### **Applicable Urban Design Priorities Project Should Achieve**

The redevelopment of Red Bird Mall has represented an important and significant opportunity to bring much needed shopping, dining, entertainment, and services to the surrounding communities and the growing mixed-use community of Red Bird. A new Tom Thumb grocery store and outlying commercial retail building(s) on 5 acres will bring much needed fresh food and pharmacy services to southern Dallas.

## **Red Bird Redevelopment**

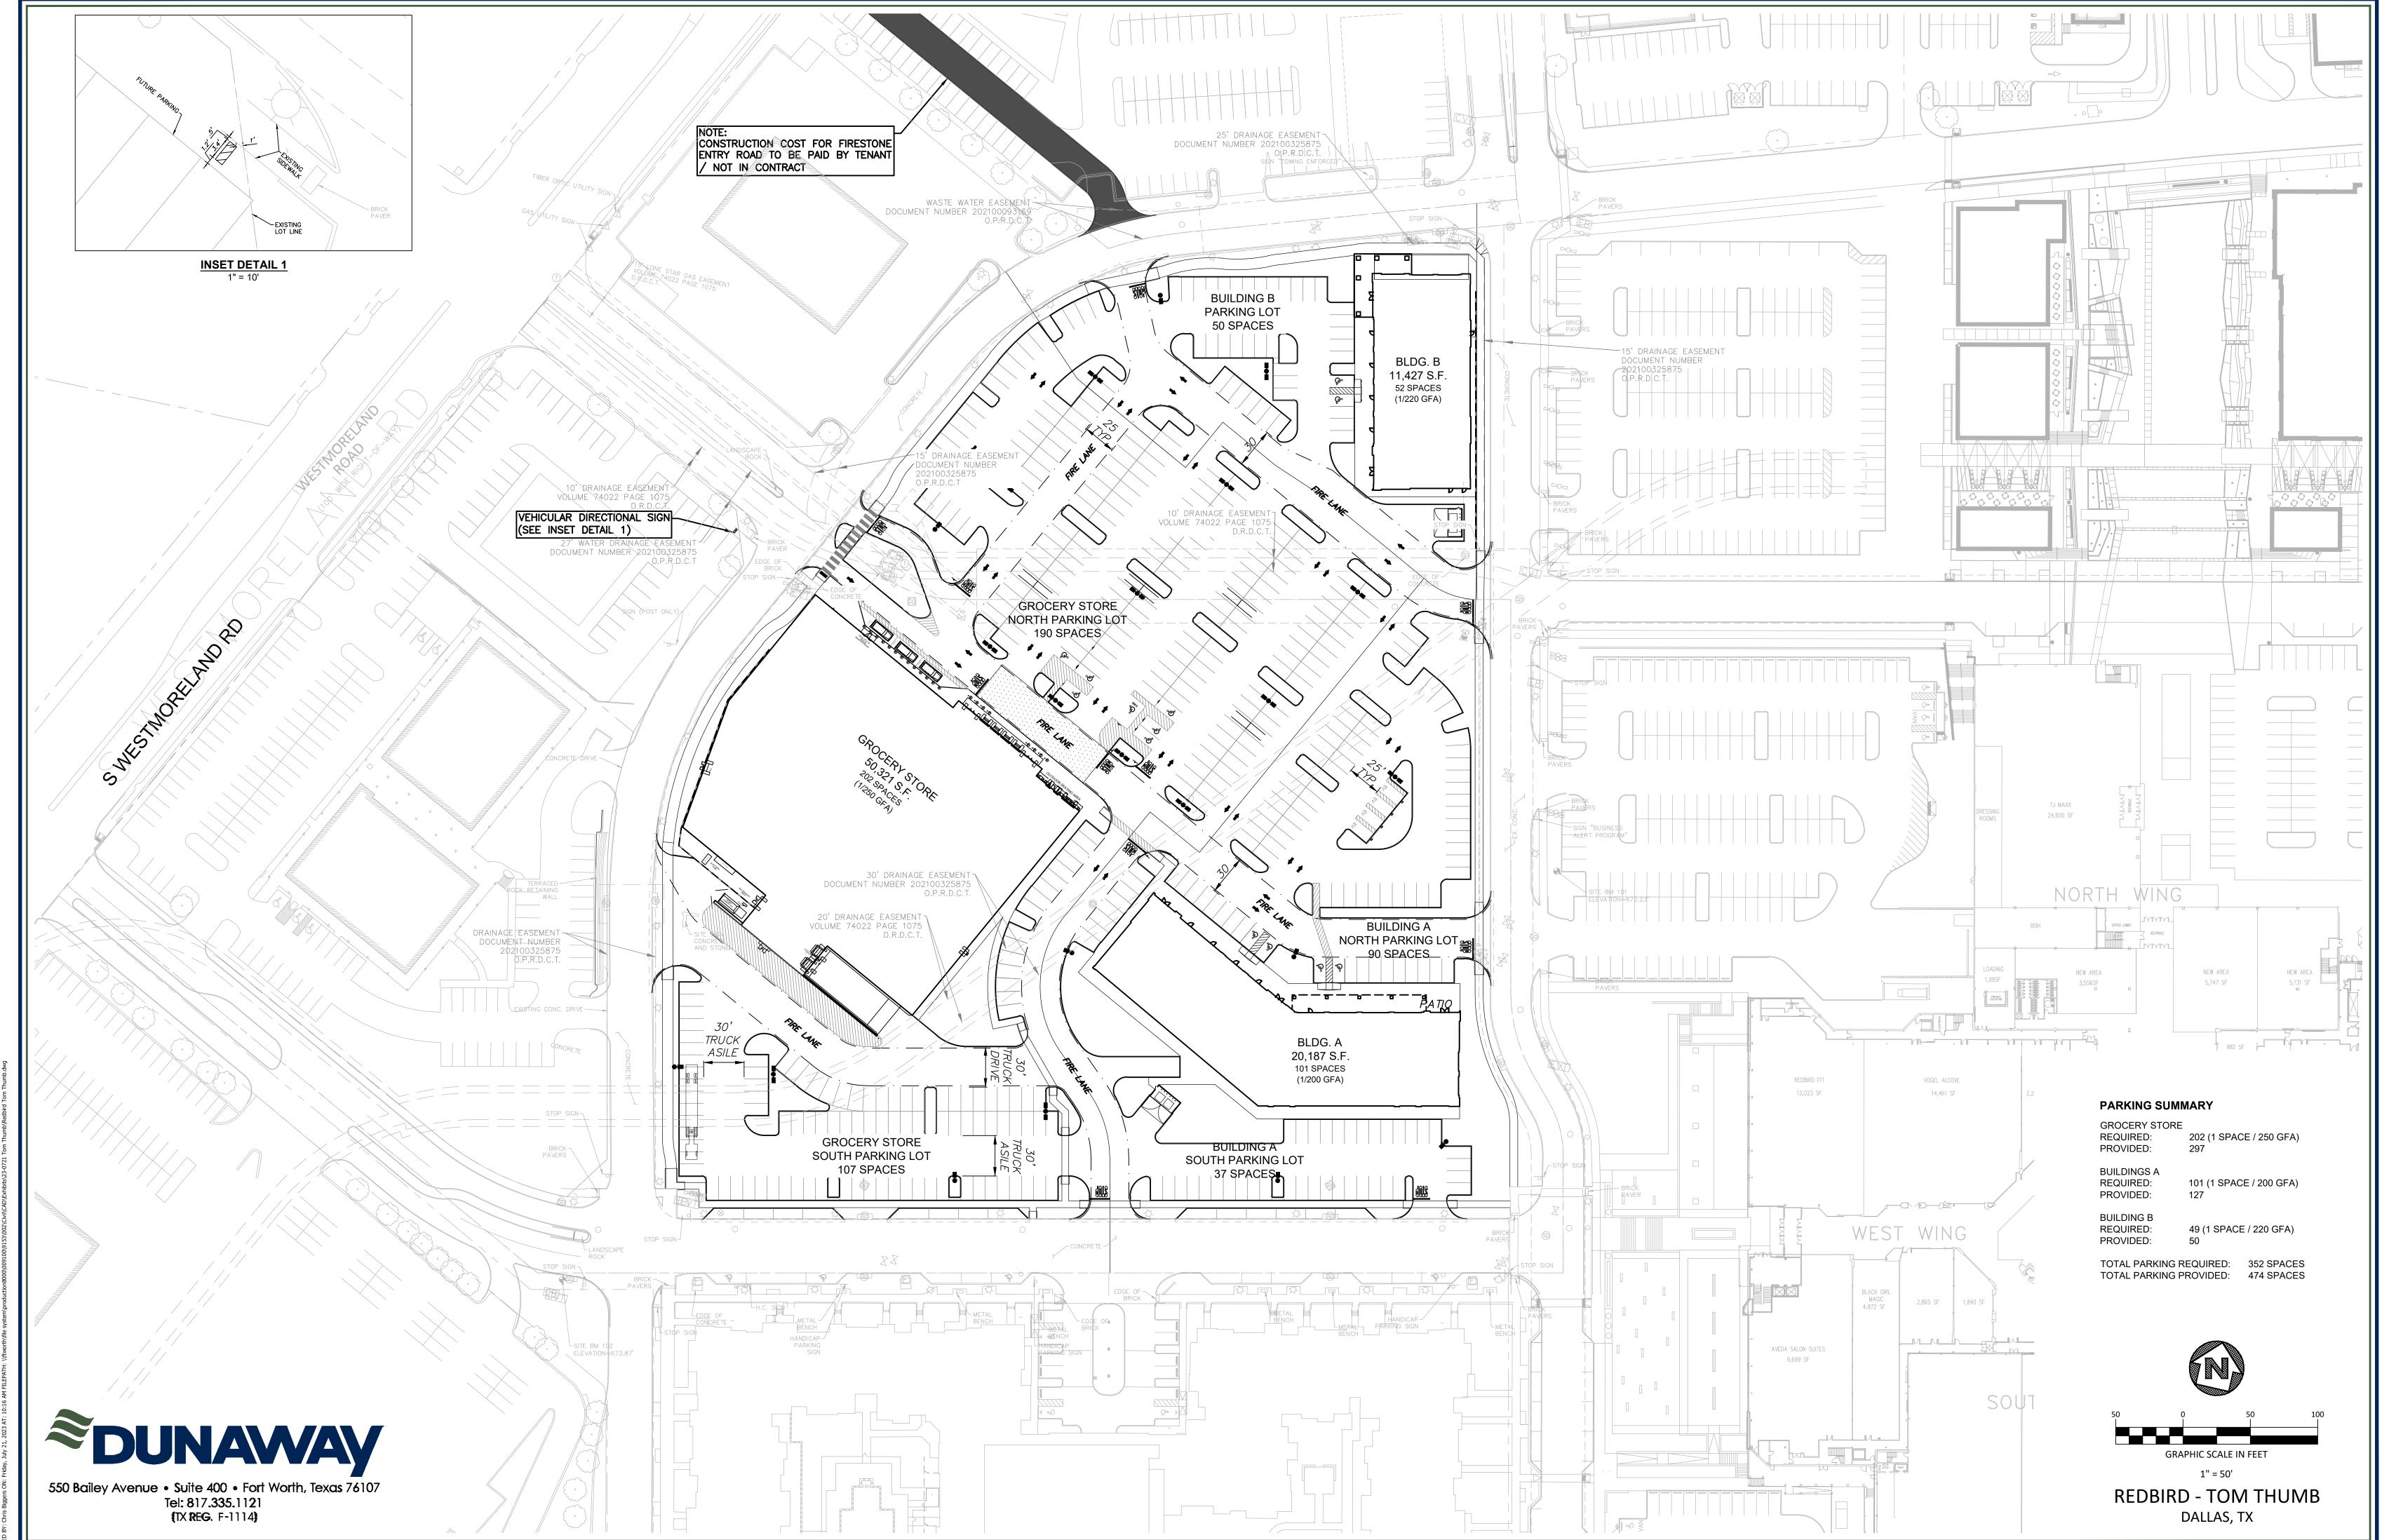
- [2] Design of a safe, comfortable and convenient pedestrian network on adjacent roadways and internal through the parking lot will add to the walkability of the Shops at Red Bird and provide a viable driving alternative to access the development's growing selection of goods and services.

- Attention should be given to the design of paths around and through the site to ensure safe and convenient pedestrian access to building entries and enhanced outdoor spaces by buffering paths from vehicles with landscaping and trees, minimizing conflict points at driveways and drive aisles, and incorporating lighting and streetscape furniture at key locations.

- [3] Parking, loading areas, utilities and services are necessary functional areas, but elements that may not directly support a vibrant pedestrian environment.

Consider locating these elements to minimize their impact on the public realm and overall pedestrian experience. Where possible, the design of surface parking areas should allow multiple functions including integrating stormwater retention, buffering, landscaping, lighting, shading, and usable special event space. Siting and screening untilities, trash, and recycling enclosures from the public realm and neighboring buildings should also be given special attention.

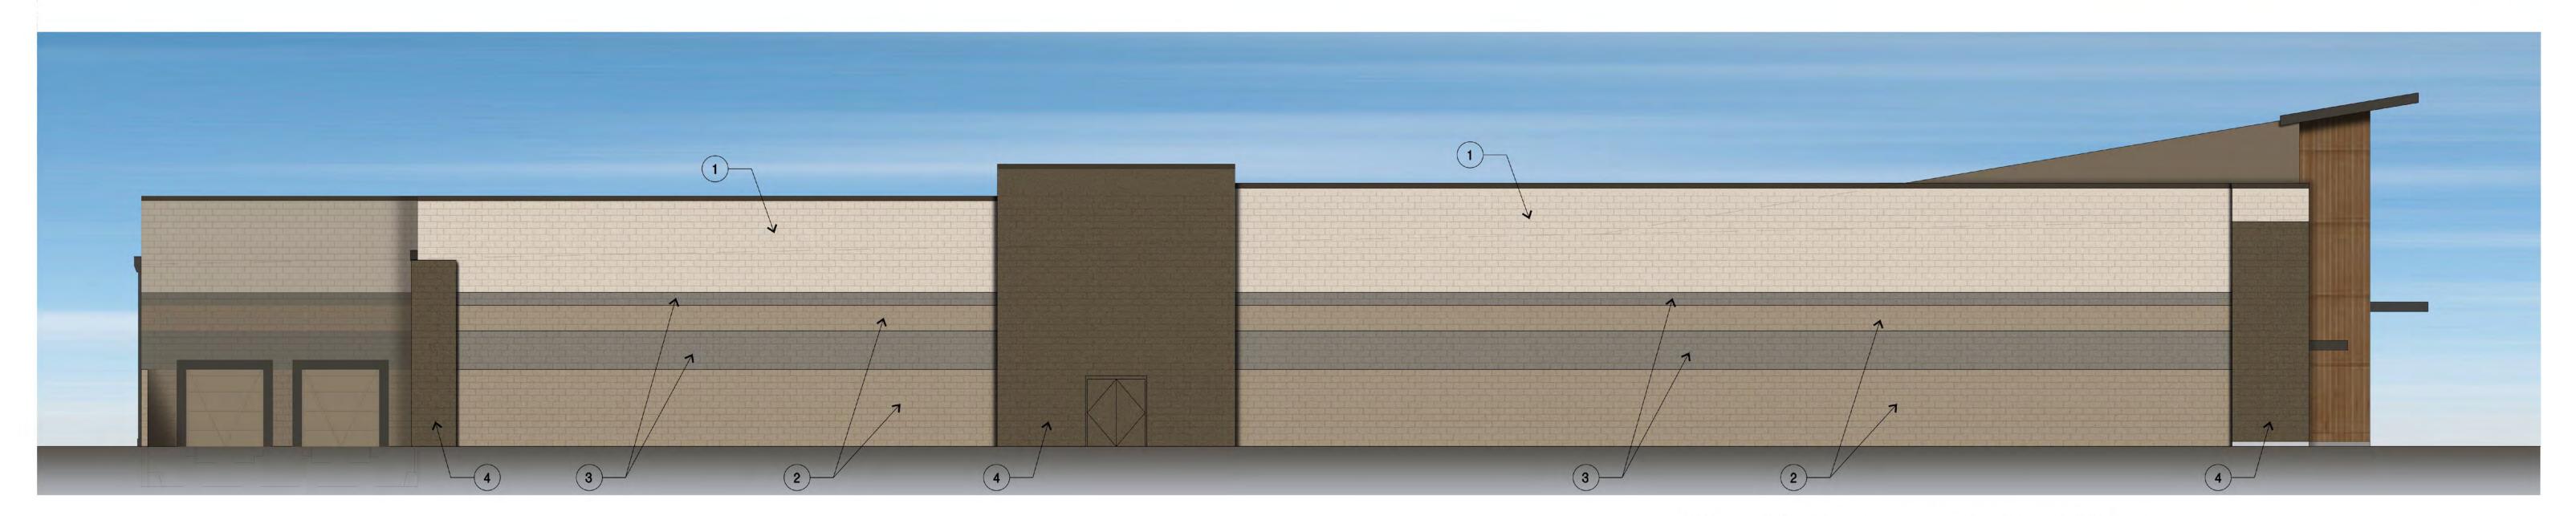
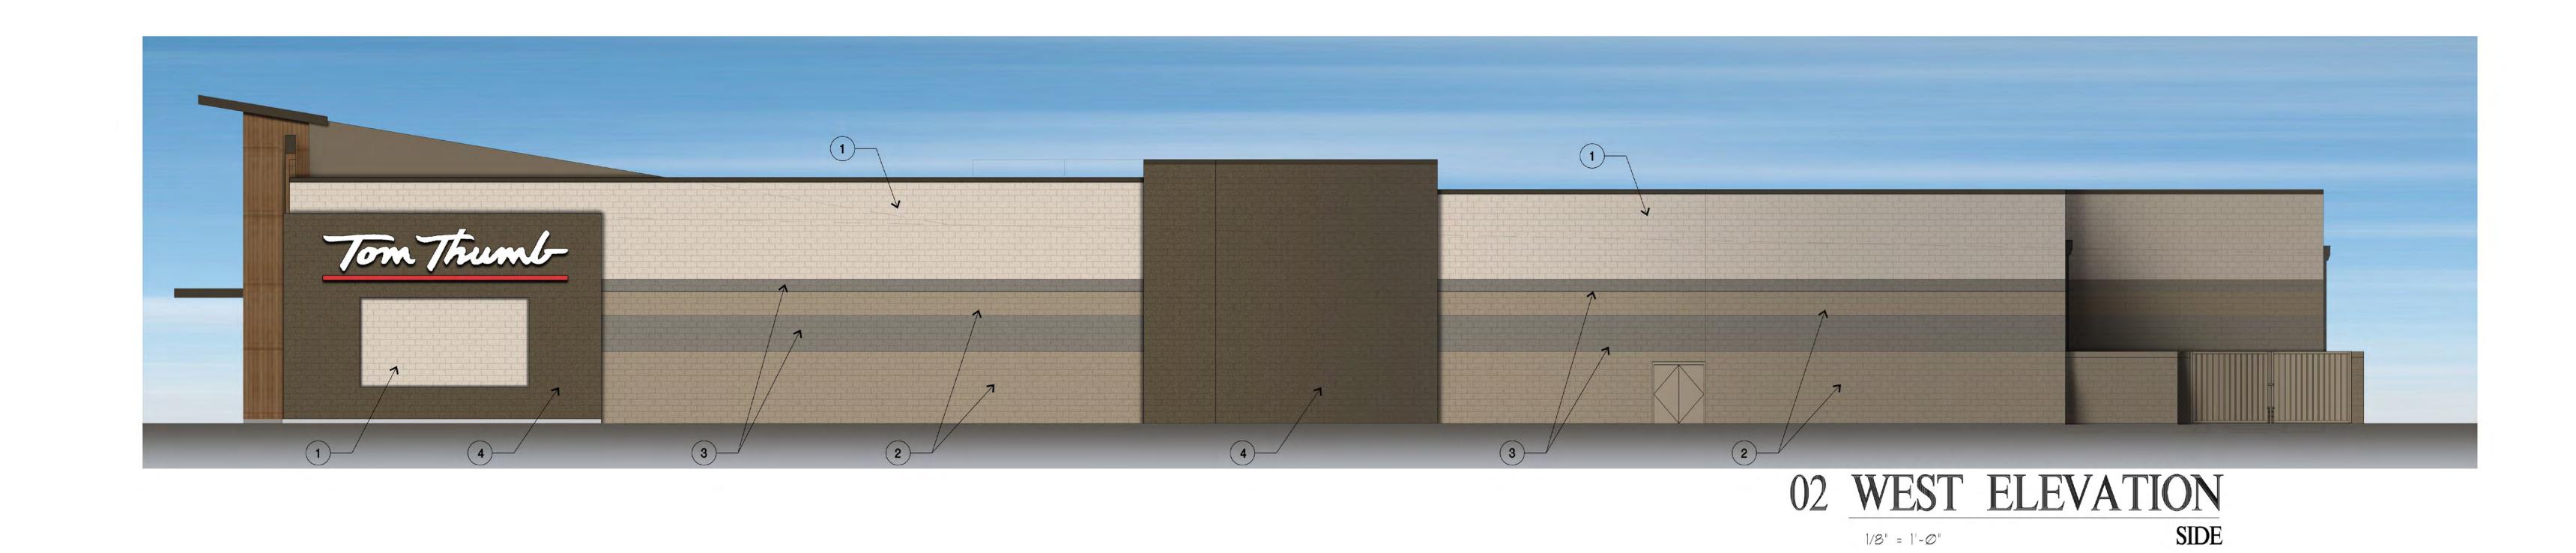
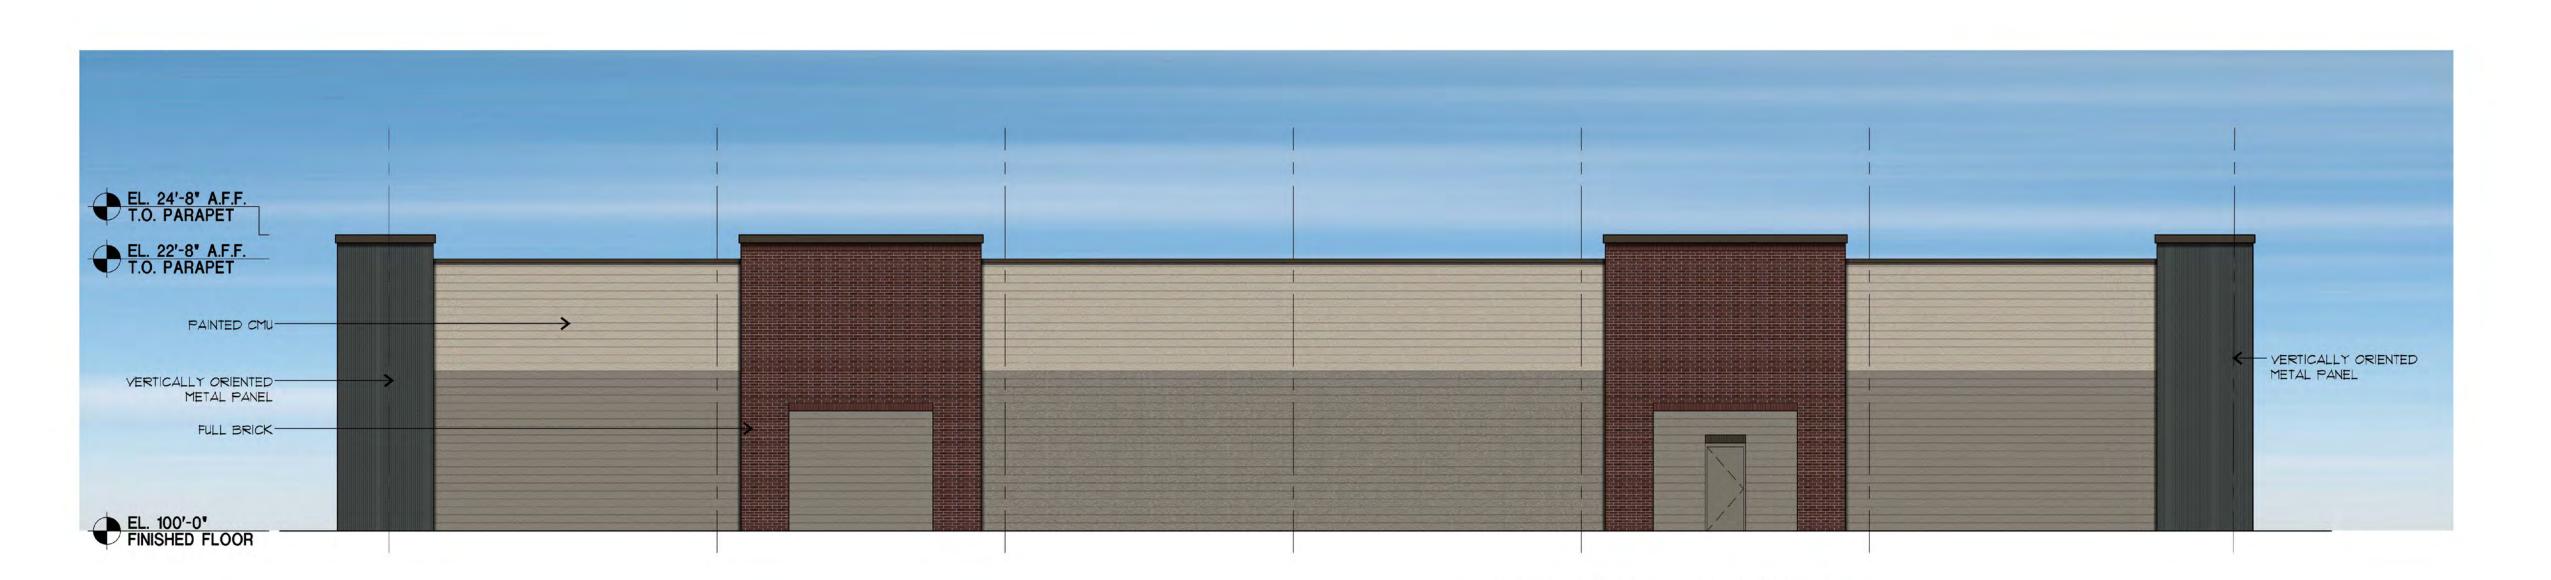
- [1] Focus attention on the design of the grocery store's exterior facades to avoid large expanses of blank walls while adding interest and contributing to the activity and walkability of the site.

- To better activate the building, in spite of the operational realities that include backof house functions, wall display space and a drive-though, consideration should be given to employing strategies that add visual interest to blank facades. Examples may include multiple windows and entries, building facade articulation, signage, public art, landscaping, layering of usable outdoor space with seating, weather protection, and building material selection among others.
